Access Compliance Report

Public Rights-of-Way

(Curb Ramps)

Intersection ID: 2745	Main Street: HIGHLAND_CREEK_PY	Cross Street: SHELLEY_AV	Location:	E
ADA ID: 9597F23F60A2	Ramp Type: Perp	Initial Pass/Fail: Fail	Overall Compliance: No	Severity Score: 25
Codes/Mitigation Info/Possible Solution		Field Measurements/Component Compliance

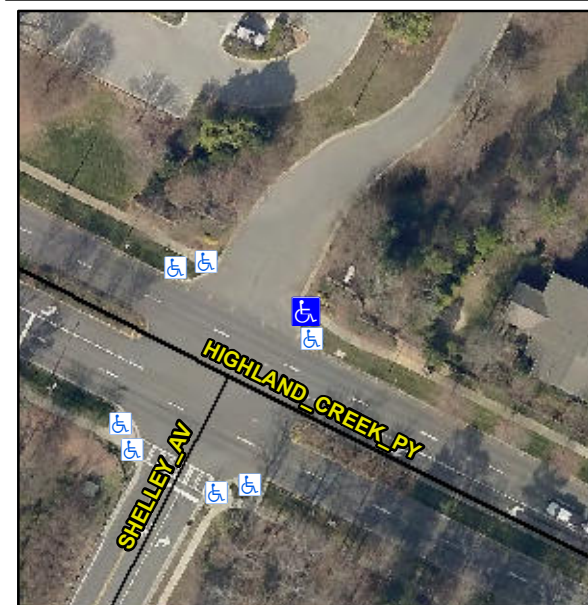
R304.2.2, R304.5.3

Compliance	Description	Data	Compliance	Description	Data
N/A	Ramp Length (in)	88.0	No	Ramp Slope (%)	8.6
Yes	Ramp Width (in)	48.0	No	Ramp XSlope (%)	5.1
N/A	Flare Type LT	N/A	N/A	Flare Type RT	N/A
N/A	Flare Slope LT (%)	N/A	N/A	Flare Slope RT (%)	N/A
N/A	Flare Traversable LT?	N/A	N/A	Flare Traversable RT?	N/A
N/A	Landing Length (in)	N/A	N/A	DWS Provided?	N/A
N/A	Landing Width (in)	N/A	N/A	DWS Contrast?	N/A
N/A	Landing Slope (%)	N/A	N/A	DWS Length (in)	N/A
N/A	Landing X Slope (%)	N/A	N/A	DWS Full Width?	N/A
N/A	Landing Curb? (Y/N)	N/A	N/A	DWS Offset (in)	N/A
N/A	Shared Landing?	N/A			
N/A	Gutter Ponding?	N/A	N/A	Gutter Slope (%)	N/A
N/A	Gutter Lip Ht (in)	N/A	N/A	Gutter X Slope (%)	N/A
N/A	Painted X Walk1?	No	N/A	Painted X Walk2?	N/A
	X Walk 1 Direction	To NW		X Walk 2 Direction	N/A
N/A	X Walk 1 Width (in)	N/A	N/A	X Walk 2 Width (in)	N/A
	X Walk 1 Slope (%)	7.3		X Walk 2 Slope (%)	N/A
	X Walk 1 X Slope (%)	3.2		X Walk 2 X Slope (%)	N/A

Remove & Replace Entire Ramp.
